Preliminary Groundwater Mounding Analysis Review Thorndike Place: Near Dorothy Road, Arlington

Michael Mobile, Ph.D., CGWP
May 2, 2024

(RE: Thorndike Place, Dorothy Road, Arlington, Massachusetts – Preliminary Review of Applicant’s Groundwater Mounding Analysis)

DRAFT – 5/2/24

**2-Year Event
(50% Chance)**

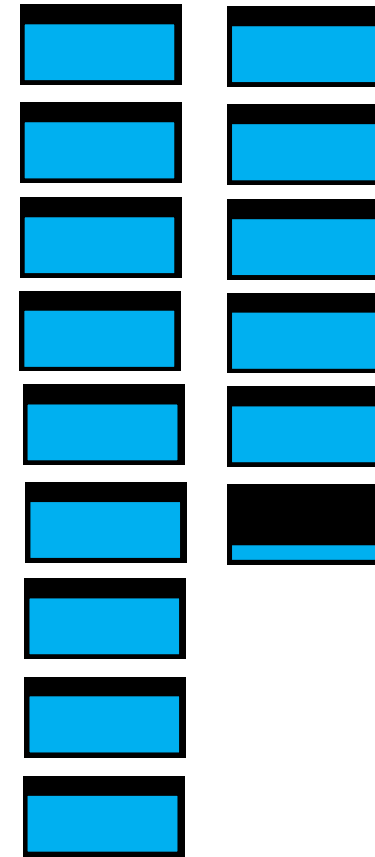
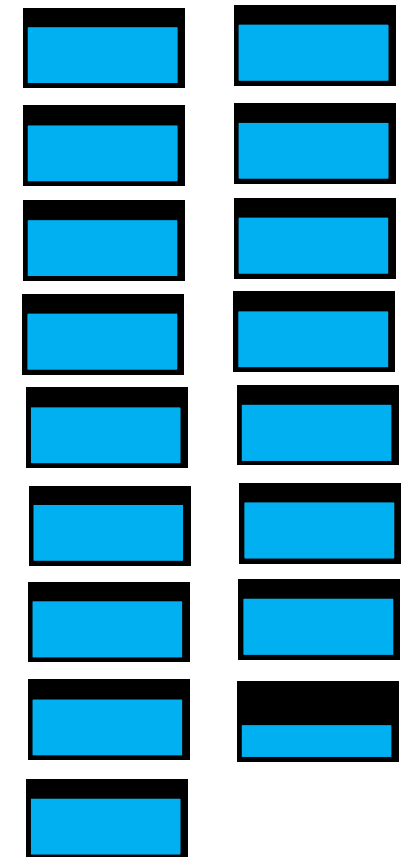
**~14.2X the RRV
38.8X the duration**

**100-Year Event
(1% Chance)**

**~16.5X the RRV
44.9X the duration**

INF-1 - Modeled groundwater mounding at basin center

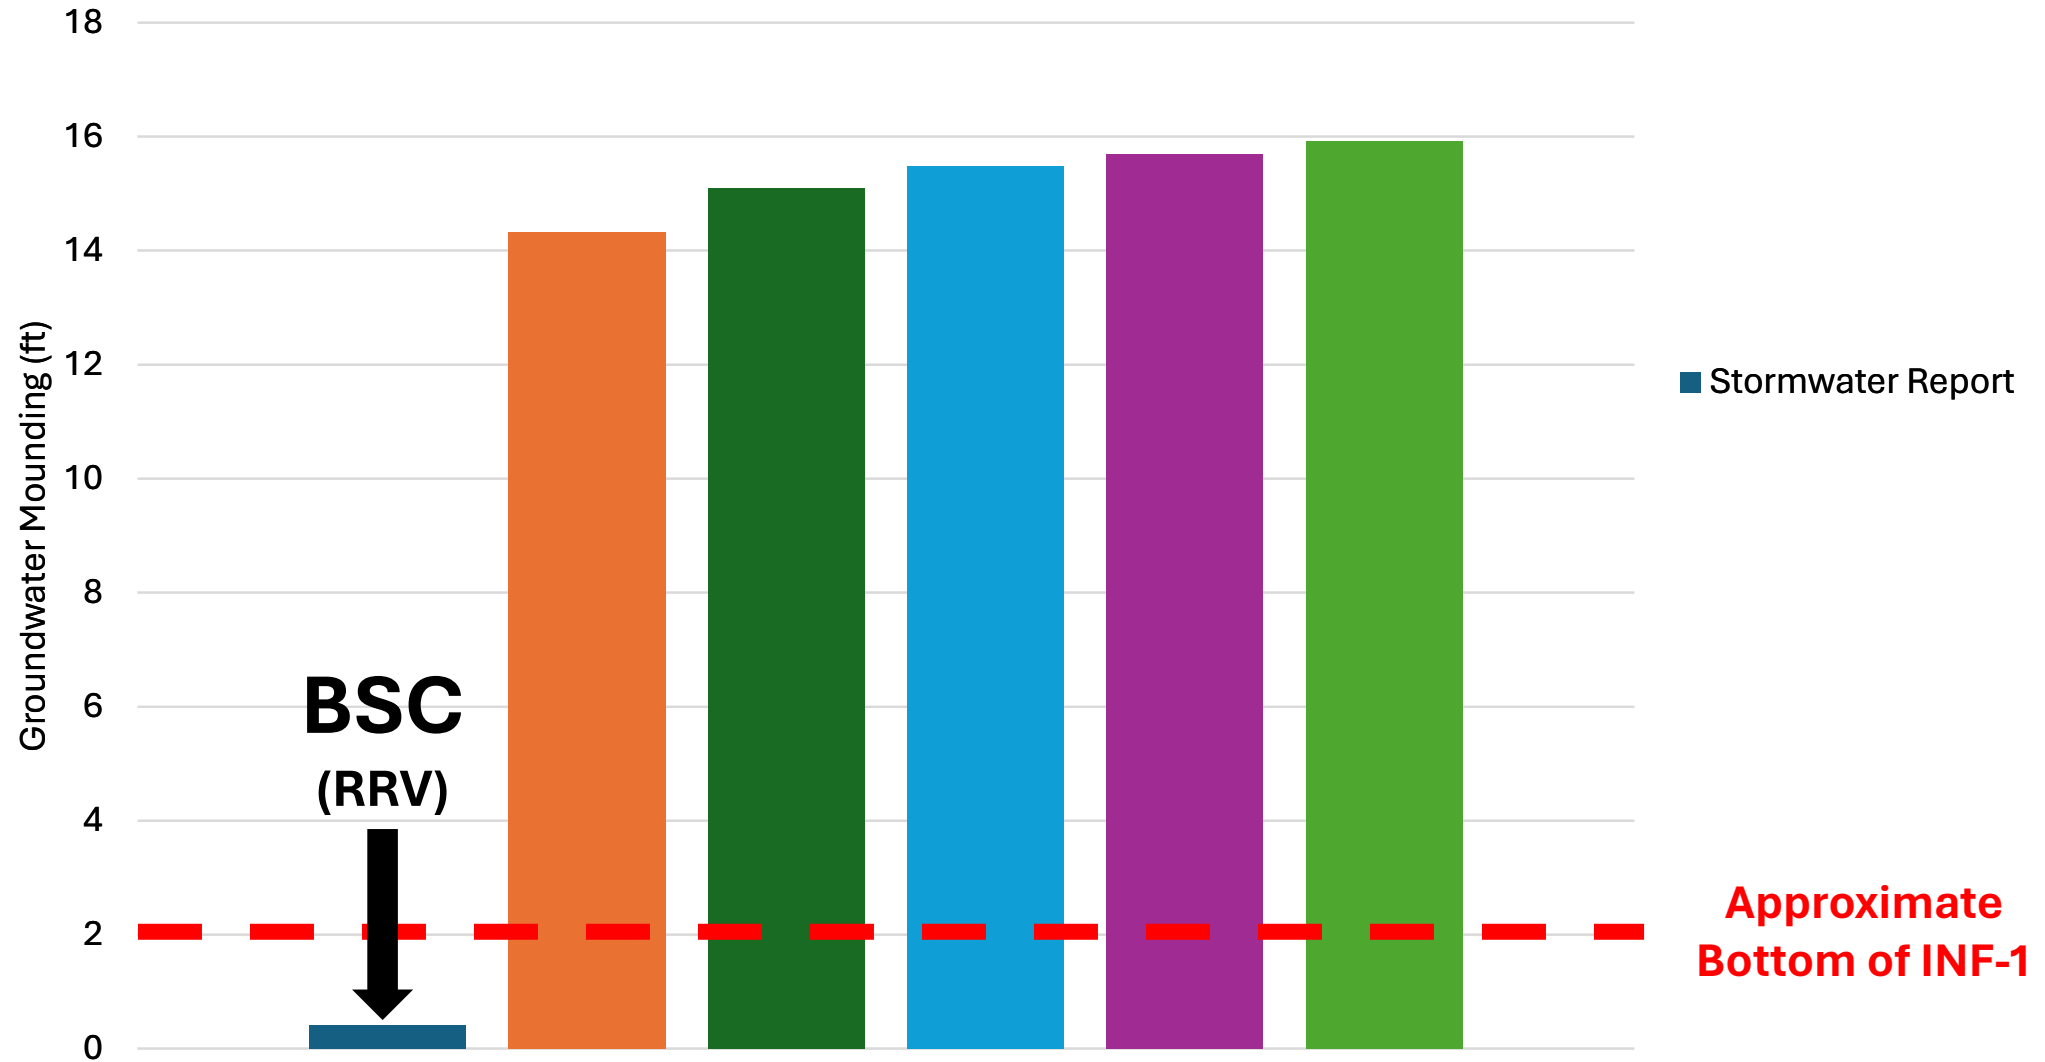
As the infiltration system has more than 2-feet but less than 4-feet separation to estimated seasonal high groundwater, a mounding analysis has been performed in accordance with the Hantoush Method to ensure that a groundwater mound does not extend into the bottom of the infiltration system preventing infiltration of the required recharge volume. This analysis is included in Section 6.0 of this Report.
